AGENDA
ARCHITECTURAL REVIEW BOARD MEETING
Public Meeting Room, Village Hall
Tuesday, June 18, 2019
7:00 p.m.

- 3.1 Public Hearing regarding Wall Sign Variations to Increase the Sign Face Height from the Maximum Permitted 3' to 4'-3¼" (East Elevation); Increase the Sign Face Height from the Maximum Permitted 3' to 6'-10" and Increase the Sign Letter Height from the Maximum Permitted 2' to 3' (North Elevation); and Provide Internal Illumination through the Face of Individual Letter Sets (Both Elevations) – 350 Knightsbridge Parkway (Knight Bridge Pky, LLC)
- 3.2 Workshop regarding Site Design, Building Elevations, Landscape Plans, Exterior Lighting, Parking, and Exterior Signage for a Proposed Hotel Building – 350 Knightsbridge Parkway (Knight Bridge Pky, LLC)

UNAPPROVED Minutes of the regularly scheduled **ARCHITECTURAL REVIEW BOARD** held on Tuesday, May 21, 2019 in the Public Meeting Room of the Village Hall, One Olde Half Day Road, Lincolnshire, IL

3.2 Workshop regarding Site Design, Building Elevations, Landscape Plans, Exterior Lighting, Parking, and Exterior Signage for a Proposed Hotel Building

WALL MOUNTED SIGN: EAST ELEVATION

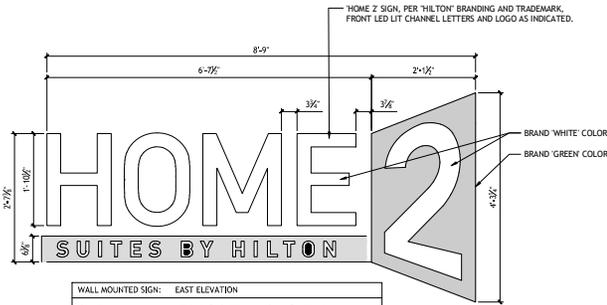
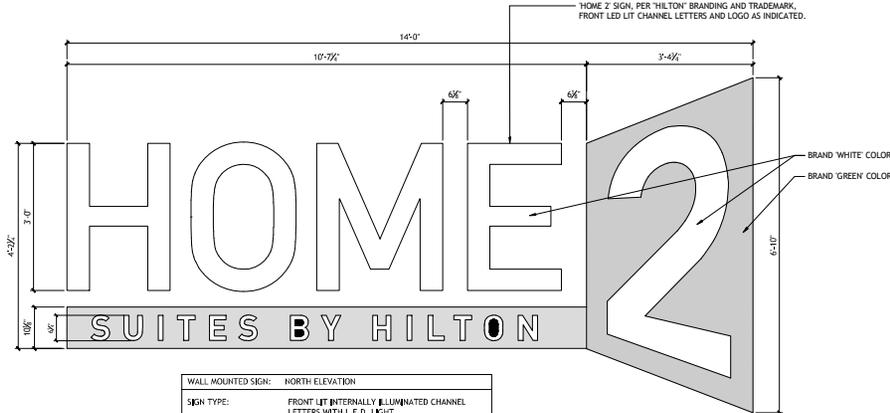
1. Increase the sign face height from the maximum permitted 3’ to 4’-3¼” (Section 12-9-1-B, Table 3).
2. Provide internal illumination through the face of individual letter sets, rather than the code-required backlit/halo illumination for this property (Section 12-9-1-B-9).
